Responses to comments from
Planning Department, Lands Department,
Agriculture, Fisheries and Conservation Department
and Highways Department

Comments from Planning Department dated 22.12.2025

**S. 12A Application for
Rezoning Application from "AGR" and "GB" to "OU (Columbarium)"
Various Lots in D.D. 41
and Adjoining Government Land, Tong To, Sha Tau Kok, N.T.**

Plan Showing the Viewpoints of Photographs
Structure on Government Land Has been Removed

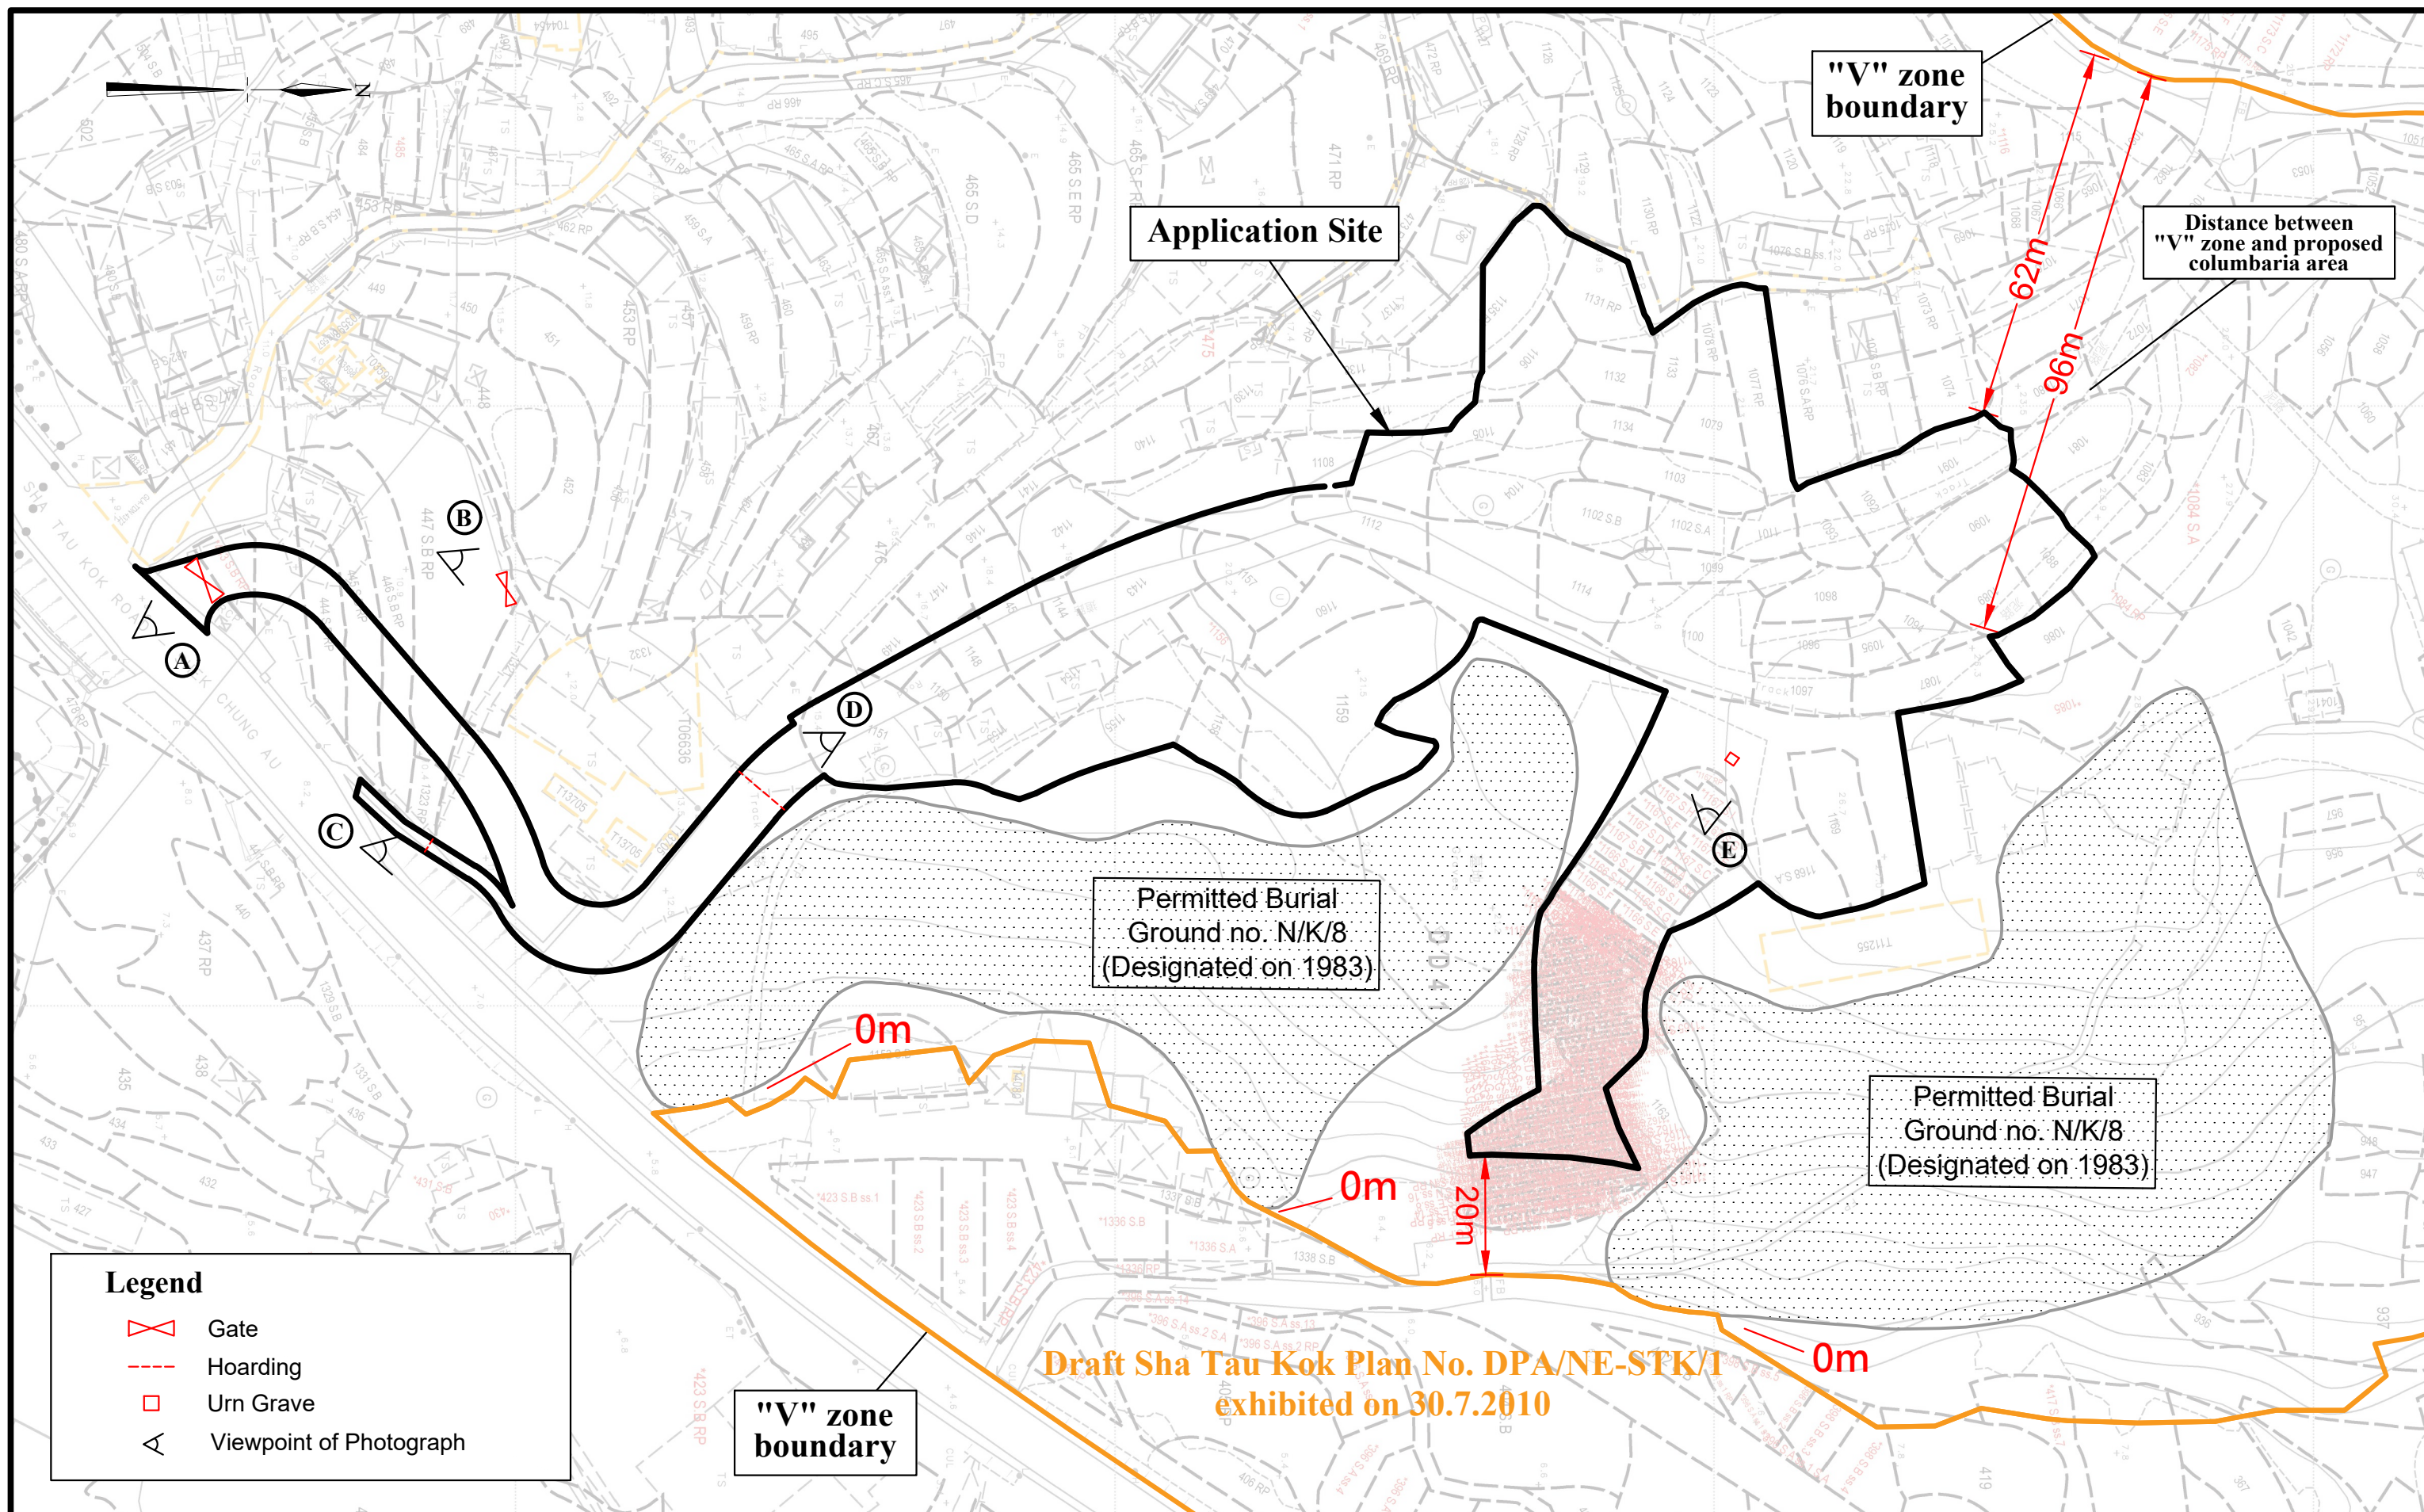
Comments	Responses
<u>Inclusion of Government Land (GL)</u>	
For point 14 of the Response-to-comment to LandsD (“the R-to-C”), it was observed during our re-inspection on 12.1.2026 that an empty urn shelter bearing number “NDO-2780-99” was found on GL within the application site. You may seek DO(N)’s comment in this regard. In particular, (i) whether approval has been given by DO(N) for the burial thereat; (ii) presumably there is no human remains buried underground. You may further clarify with DO(N); (iii) whether there is any record of urn removal according to DO(N)’s record, and (iv) whether DO(N) has any comment on the proposed removal and the removal arrangement of the urn shelter. The applicant focused on the arrangement of the urn shelter but had not responded to our previous comment (paragraph 5 of our previous memo of 7.1.2026) that “...it is noted some areas of the affected GL, particularly the portions forming the proposed access roads to the proposed development, may not be incapable of reasonable separate alienation or development... the GL included in the application site may not be available/able to be granted for the subject proposal (if applied).”, which remains valid.	The empty urn shelter has been removed. Please find attached letter from the owner of the empty urn shelter and four photographs for details.

The applicant had a phone conversation with Senior Land Executive DLO/N Mr. CHOW Wai Choi on 8.1.2026. As a result of the discussion, the applicant removed the structures on G.L. and agreed to handle the empty structure according to the discussion:

- a. the gate A near the entrance of the site (Photo A and Marked "A" on Plan) has been removed,
- b. the gate B near Lot 447 S.B RP in D.D. 41 (Photo B and Marked "B" on Plan) has been removed,
- c. the gate C near Lot 1323 RP in D.D. 41 (Photo C and Marked "C" on Plan) has been removed,
- d. hoarding near Lot 1151 in D.D. 41 (Photo D and Marked "D" on Plan) has been removed, and
- e. It is agreed that the small empty structure on GL of which the owner undertakes to remove after the Ching Ming Festival 2026 (Photo E and Marked "E" on Plan).

The structures on Government Land have been removed, and the remaining one will be removed after the Ching Ming Festival 2026. For your information, please.

Lot Index Plan

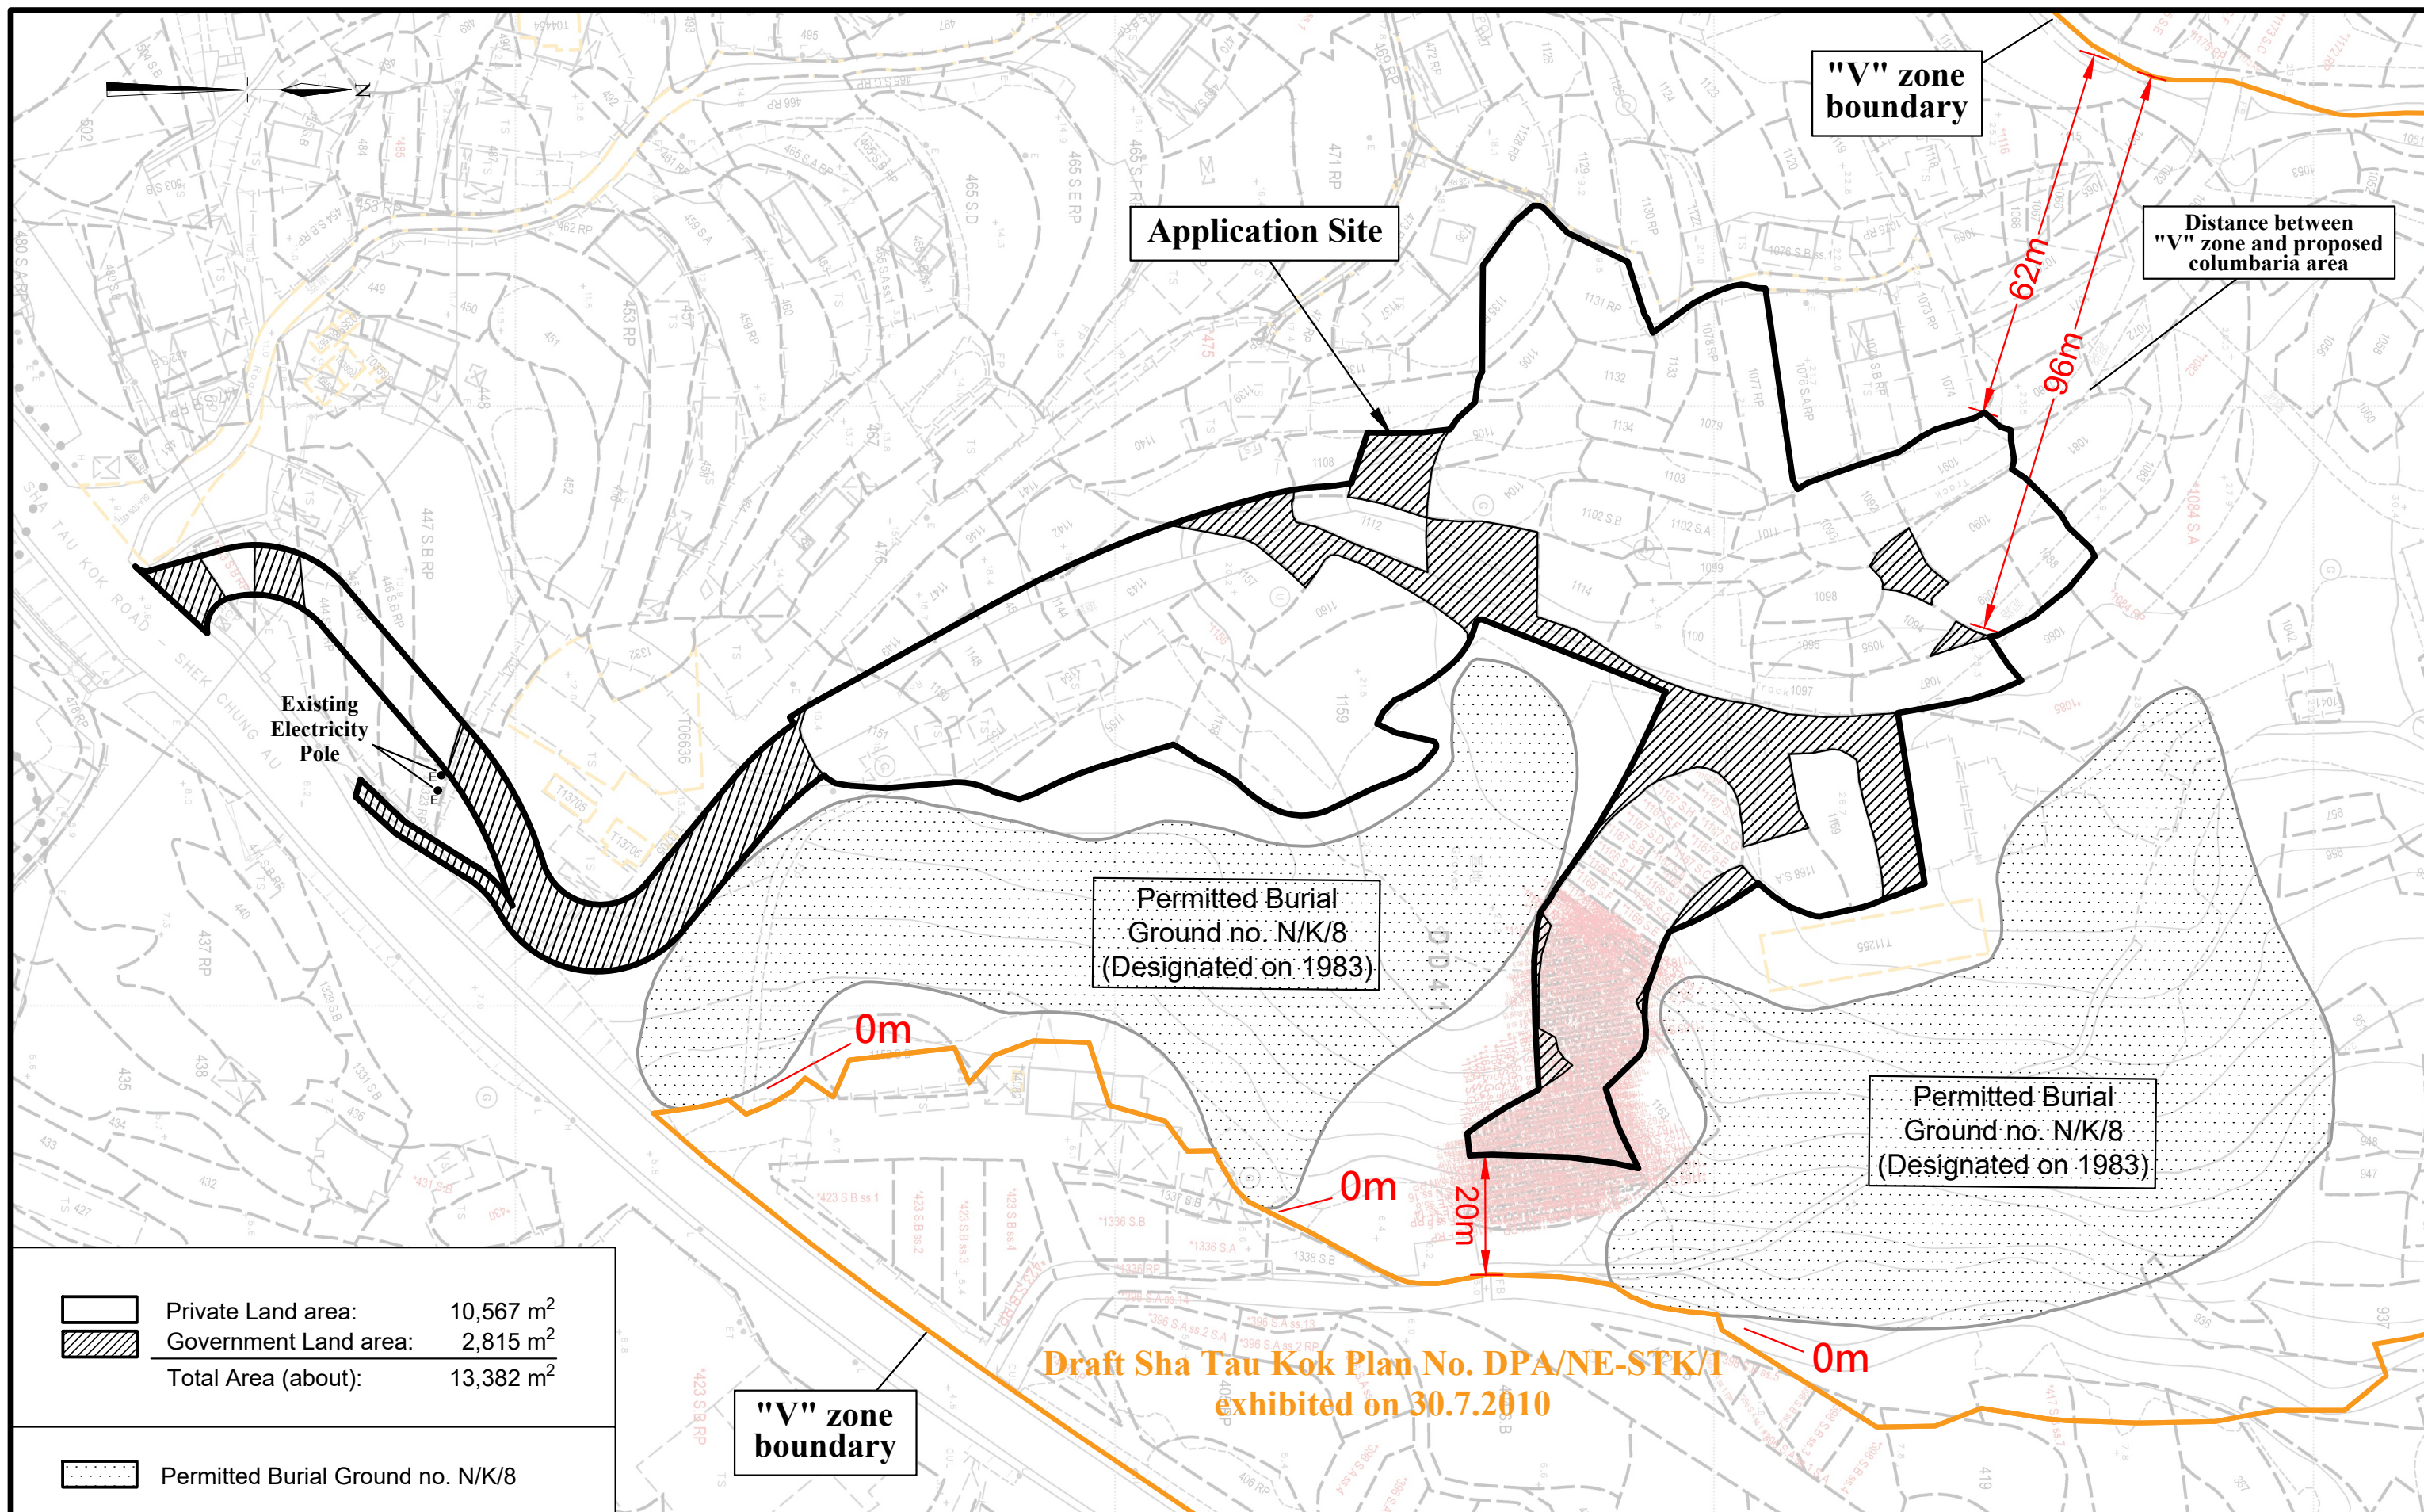
<u>Boundary of the Application Site</u>	
Comments given in paragraph 6 of our previous memo of 7.1.2026 is still valid.	The applicant is aware that the boundary of the application site may not be in a regular shape.
<u>Proposed Access Roads</u>	
In point 16 of the R-to-C, the applicant alleged that a short direct access from Sha Tau Kok Road to the columbarium area would cross some GL and private structures. However, subject to HyD’s view on necessary slope modification works (for Slope No. 3/NE-C/C45), the applicant may in fact provide a short direct access to Sha Tau Kok Road over GL. In any event, a diverted footpath from the proposed main road lacks strong justifications since no particular analysis of alternative options is seen. The applicant should therefore further review and justify the access road proposal.	The proposed footpath is diverted from the main road to avoid an existing electricity pole. Please refer to updated Lot Index Plan (Plan 2a) and attached photograph showing the existing electricity pole.

Existing electricity pole on
Lot 1323 RP in D.D. 41
